Notice of Modification

Project Approval 08_0135 for the Moolarben Coal Project Stage 2, granted by the Planning and Assessment Commission Minister for Planning on 30 January 2015.

Figure 2.1 – Indicative General Arrangement

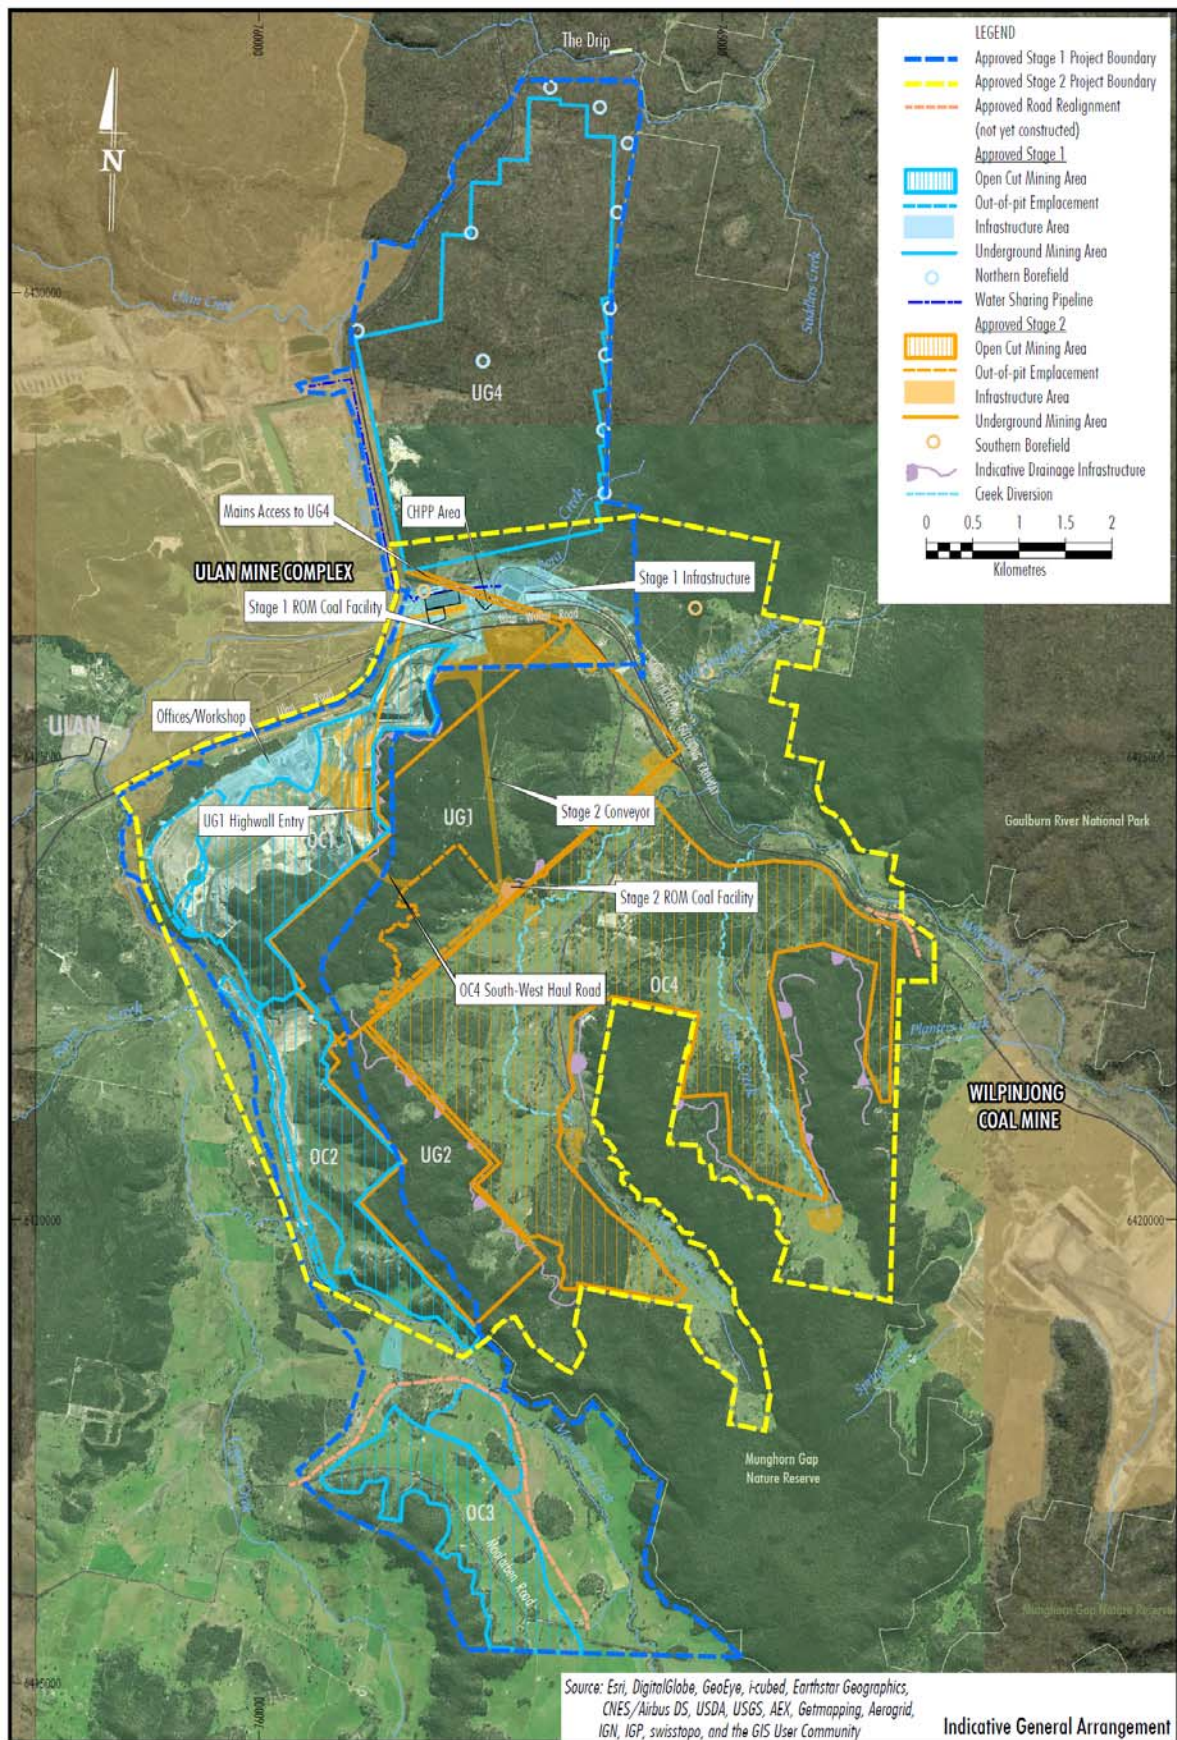
20. In Appendix 2 replace all figures with the following:

Figure 4.1 – Natural and Heritage Features

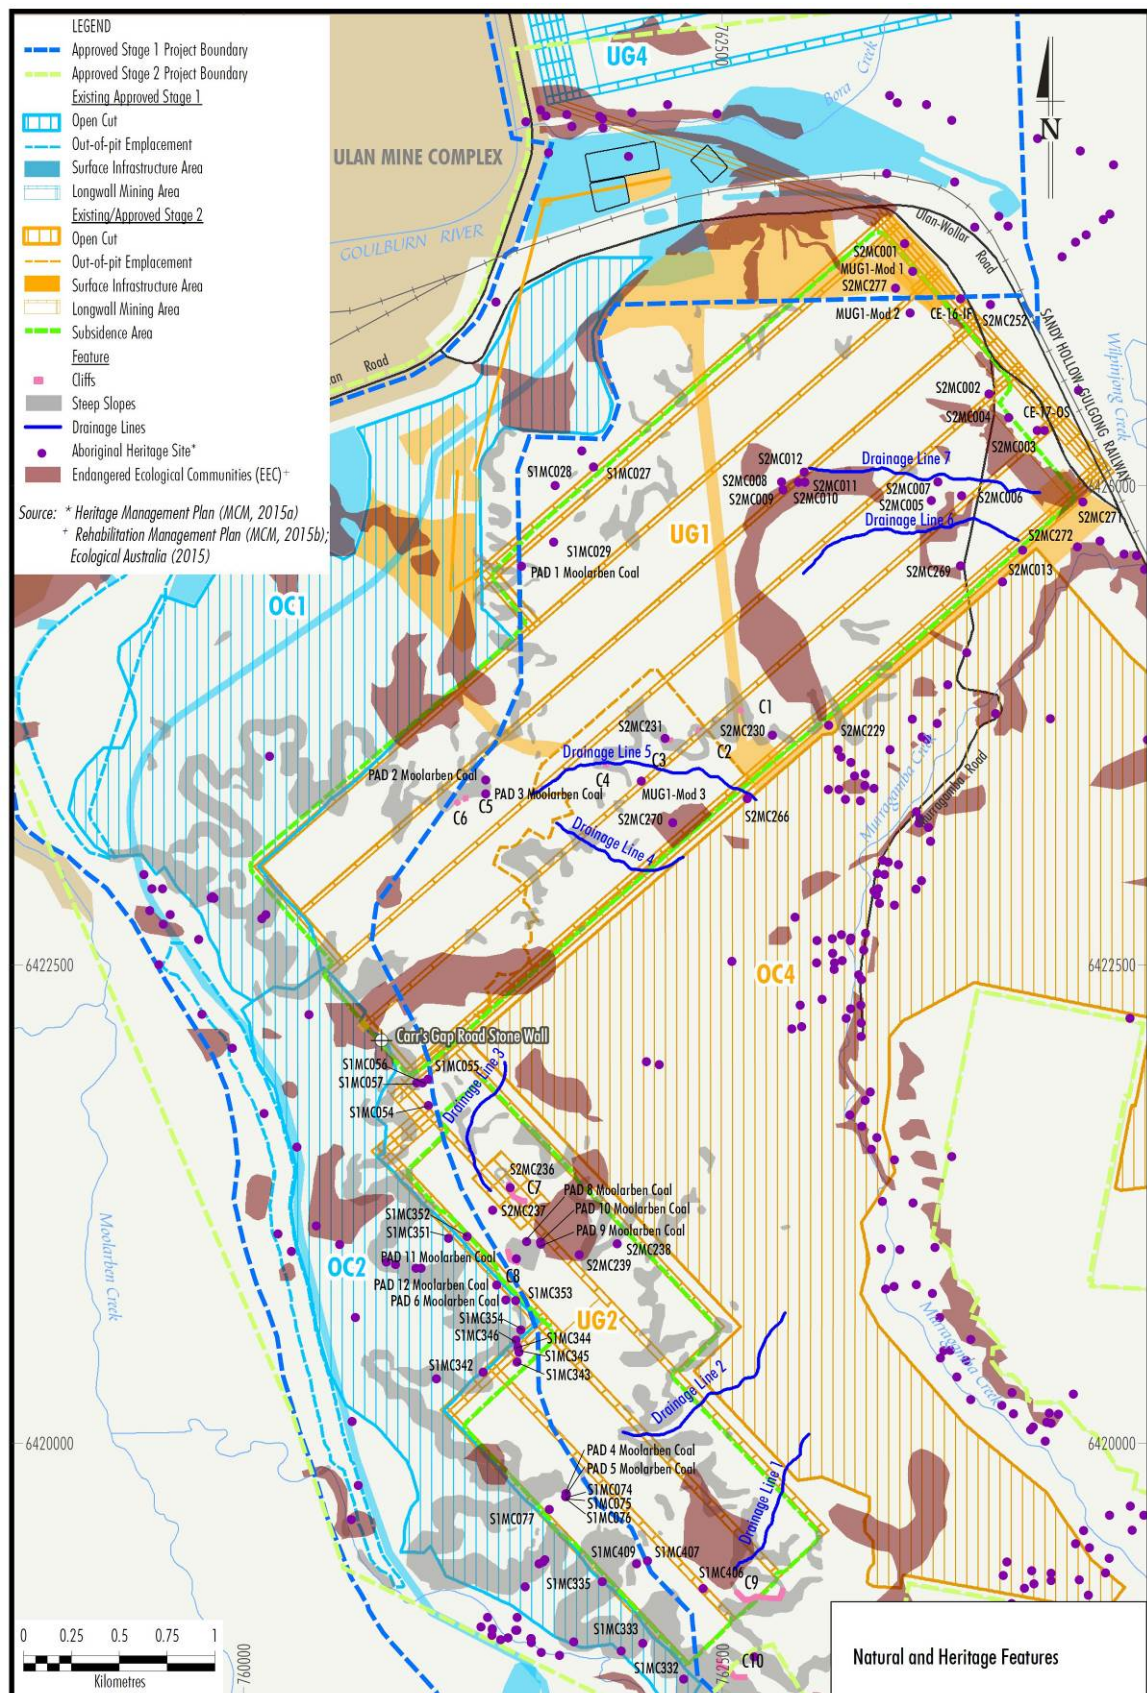
21. In Appendix 4 replace all figures with the following:
